Subject: Duke Energy Corporation  
Oconee Nuclear Station - Units 1, 2, and 3  
Docket Nos. 50-269, 50-270, and 50-287

Revisions to Topical Report DPC-NE-3003 In Support of  
Steam Generator Replacement  
Response to NRC Staff Request for Additional  
Information

Enclosed herein, please find the Duke Energy Corporation (Duke) response to the May 12, 2003 NRC staff's request for additional information concerning topical report DPC-NE-3003, Revision 1, "Mass and Energy Release and Containment Response Methodology."

### **Duke Power Response To Request For Additional Information**

(14.1 ft<sup>2</sup> Break - SG Inlet - High Initial RCS Flow w/ M3 Pump Degradation Model)

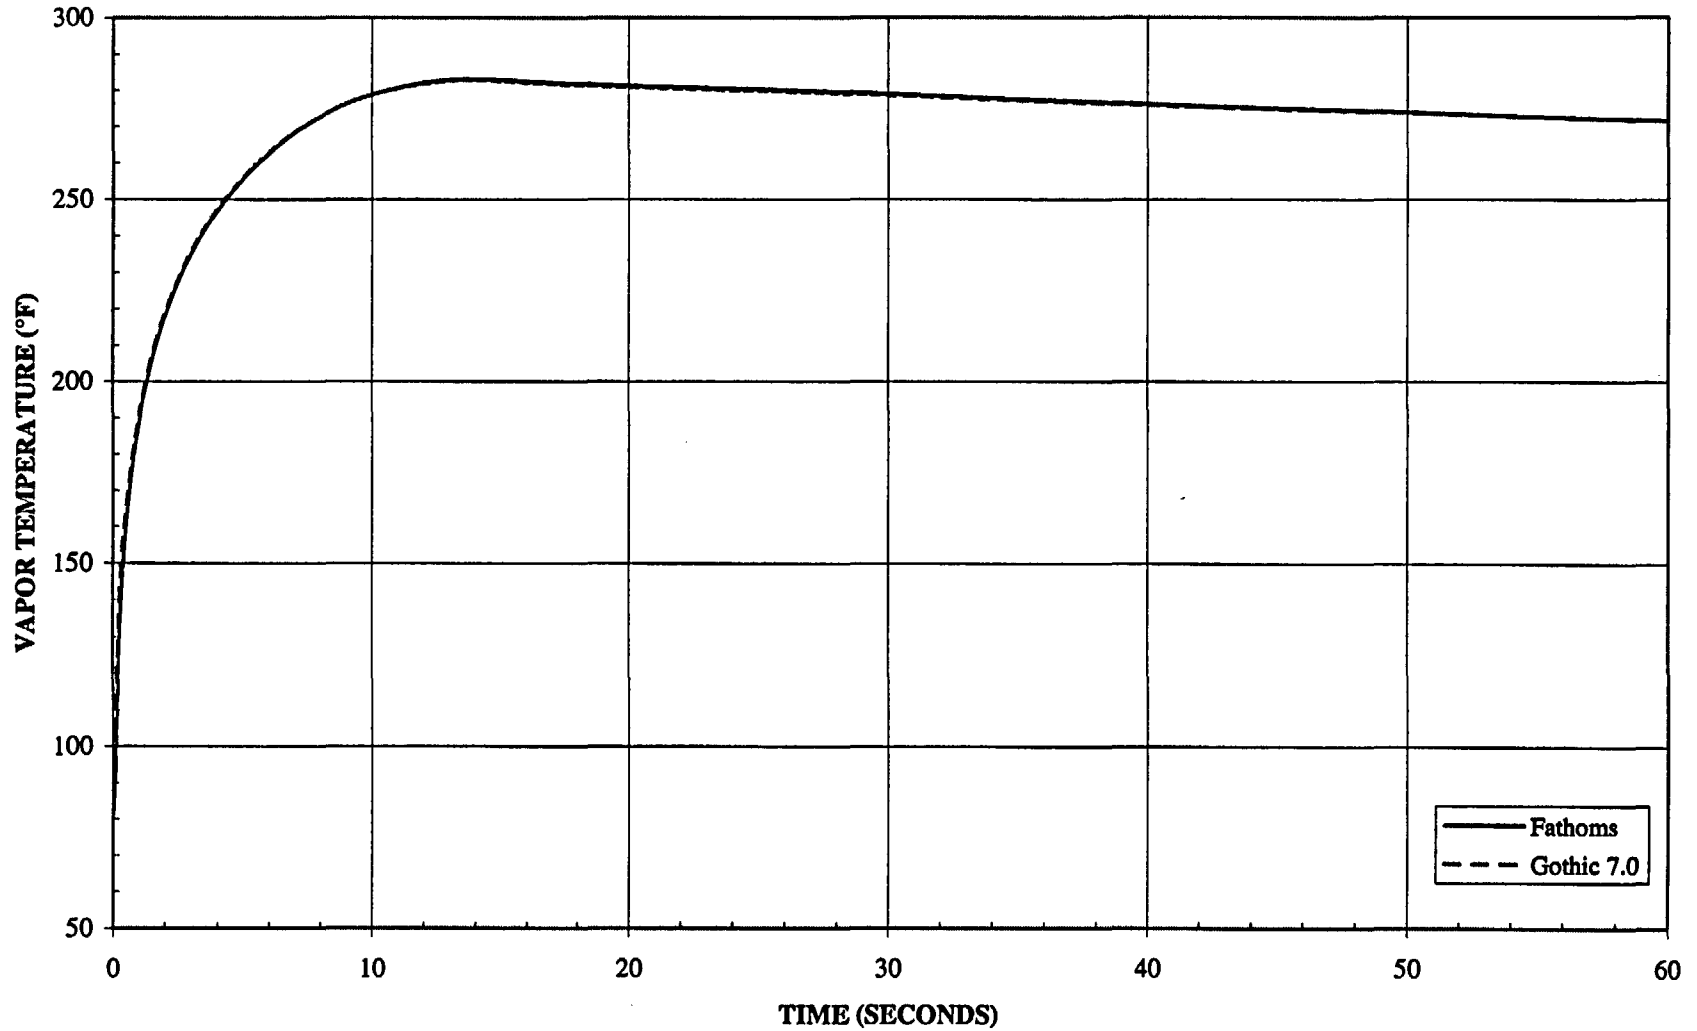
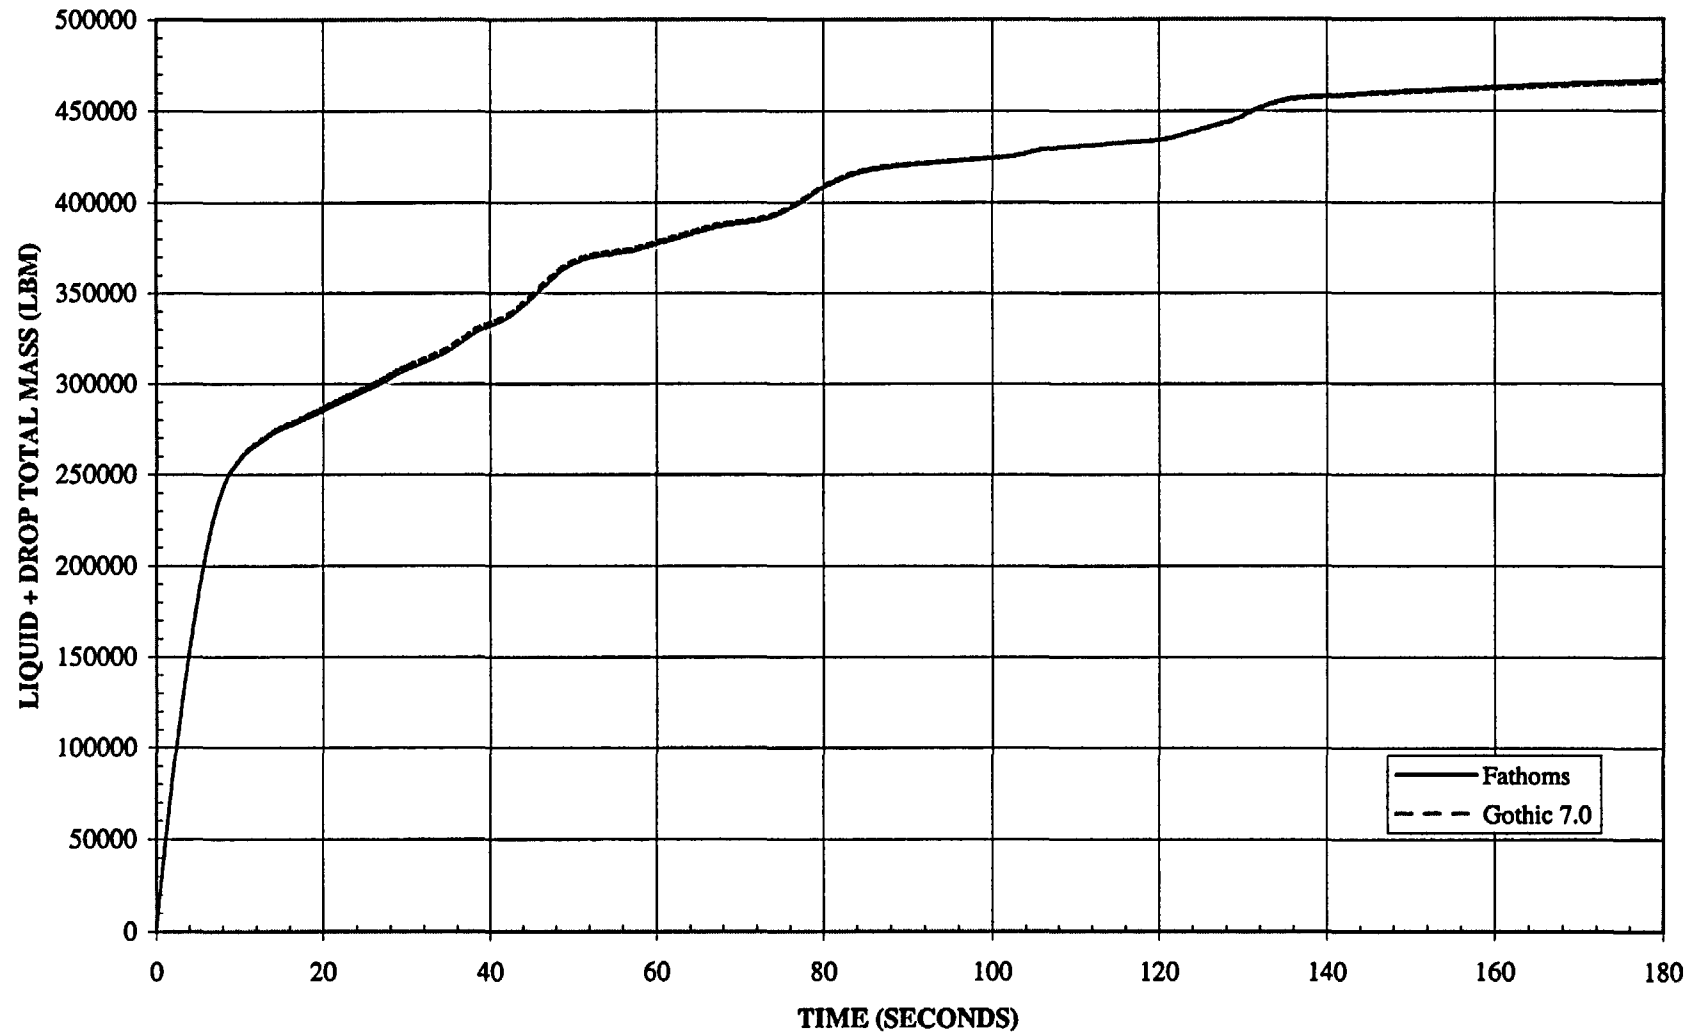
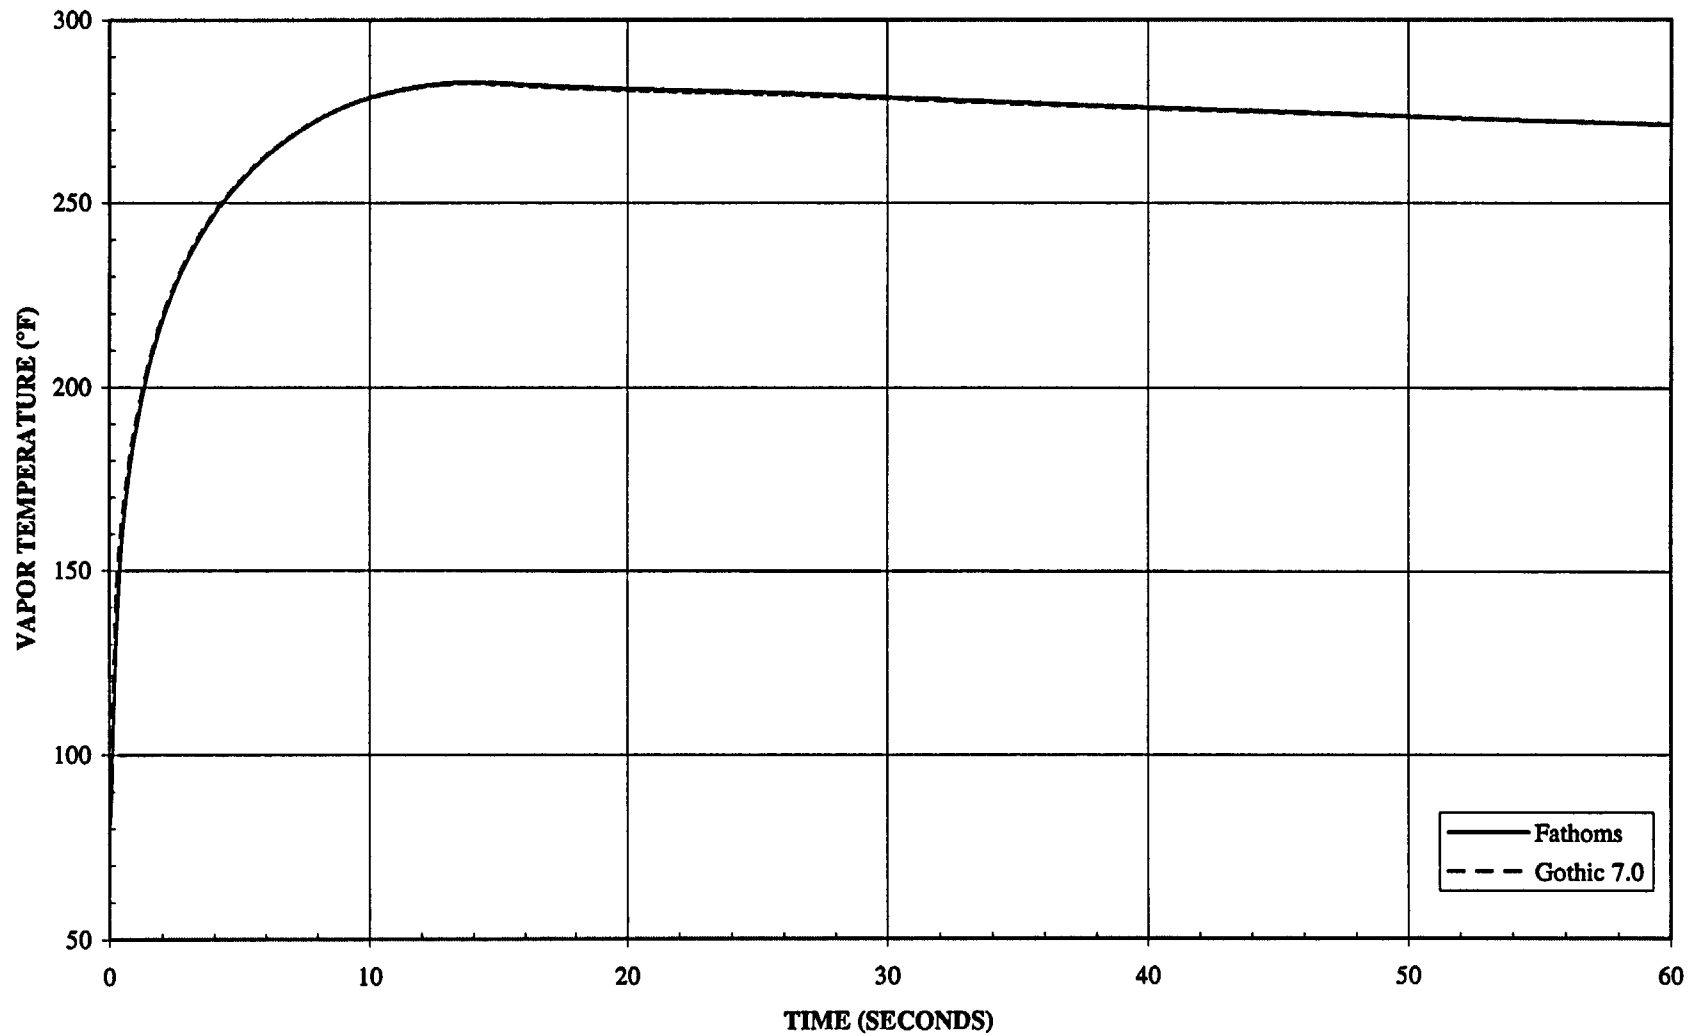
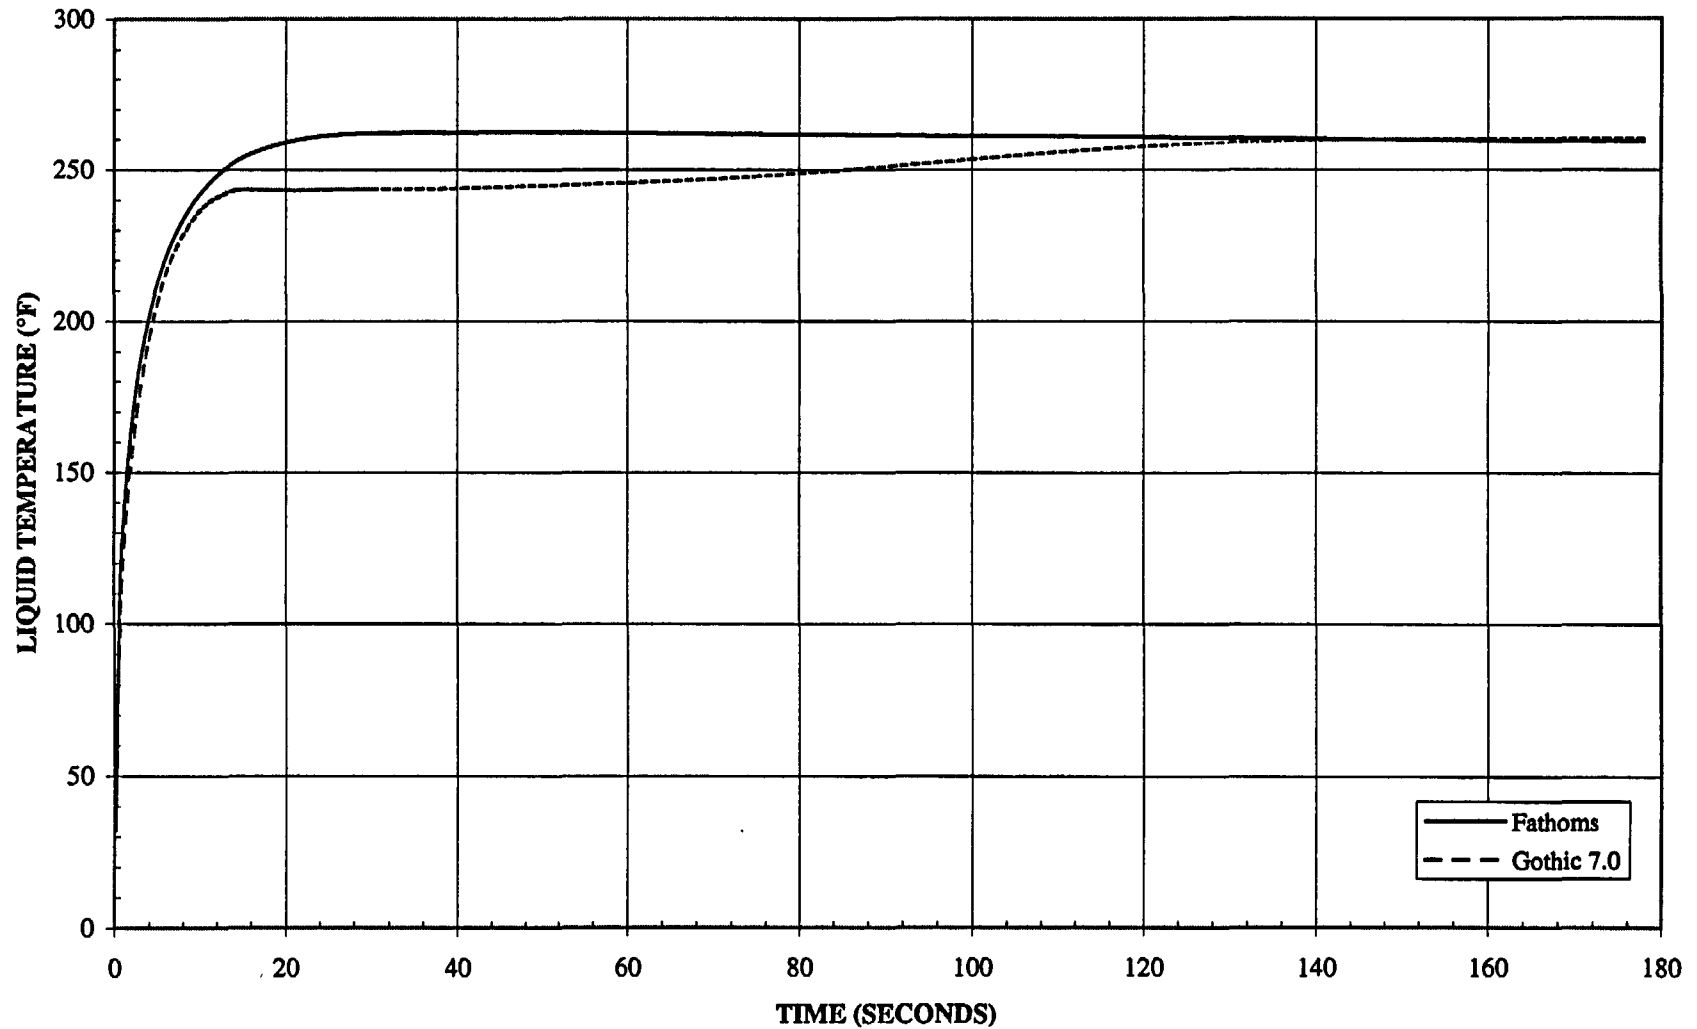
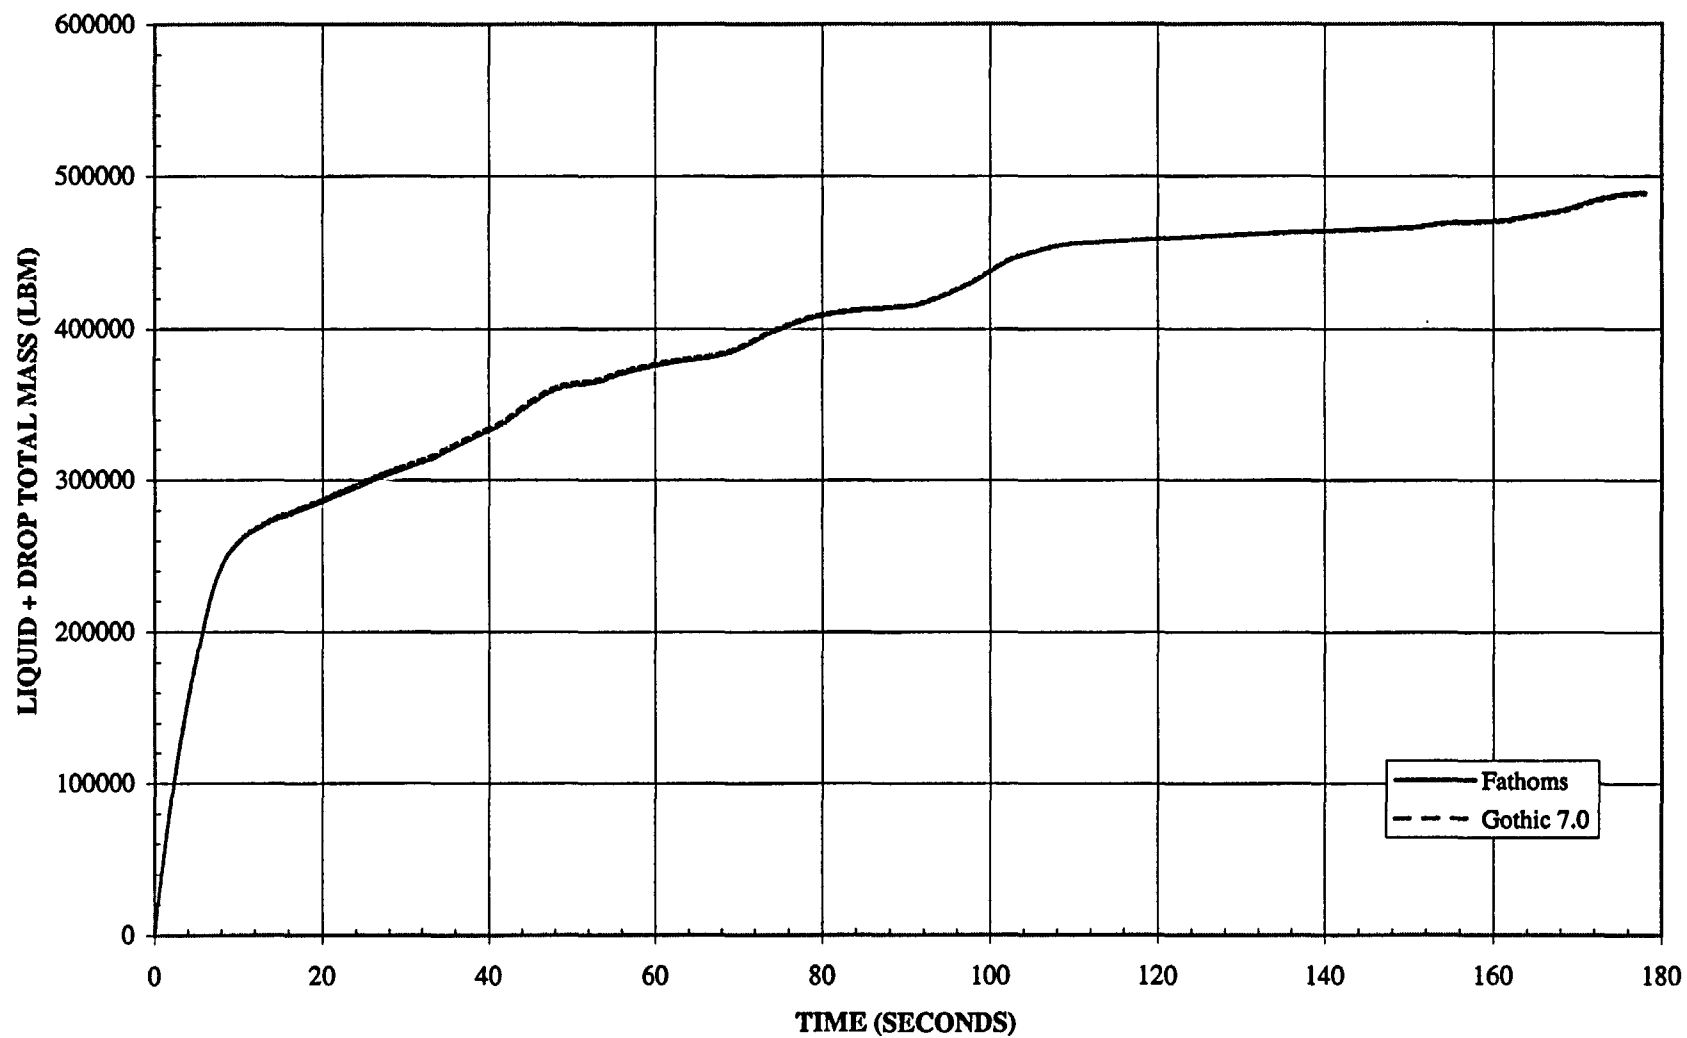
3. Please provide the results using the GOTHIC 7.0 code of peak pressure and temperature calculations for the sensitivity cases listed in Table 3.1-1 of DPC-NE-3003 in tabular and graphical form. If the results or conclusions are significantly different from those presented in DPC-NE-3003P, explain the difference.

Response: Table 3.1-1 of DPC-NE-3003 describes a spectrum of LOCA peak pressure cases including a range of break locations and sensitivity analyses for several important modeling assumptions. The staff's request is understood to focus on the difference in the predicted results from the FATHOMS and GOTHIC 7.0 code versions. Rather than show the comparison for the cases in Table 3.1-1, a different set of cases has been selected which is more focused on the current knowledge of the key sensitivity parameters. Also, the results presented are for the ROTSGs, which is the subject of Revision 1 to the topical report.

The results of the 14 code comparison analyses are shown in Table 3-1 below and in the figures that follow. In general, the pressure and vapor temperature response predictions were very similar in both magnitude and trend. GOTHIC 7.0 predictions for peak pressures and vapor temperature were slightly lower (~0.5 psig and 0.5°F). These differences are consistent with the code model differences described in the response to Question #1. Both codes predict a saturated containment atmosphere due to the large amount of drops injected. The slightly lower pressure, vapor temperature, and liquid temperature from GOTHIC 7.0 may be attributed to additional drop hold up in the atmosphere. This effectively increases the heat capacity of the atmosphere and reduces the temperature rise for a given energy addition. A comparison of the total liquid and drop masses, and liquid temperatures, show the predictions of the two codes to be essentially the same. This is consistent with the changes in the drop deposition and entrainment models discussed in Question #1. These results show that the two code versions give essentially similar results for the same break location and initial and boundary conditions.
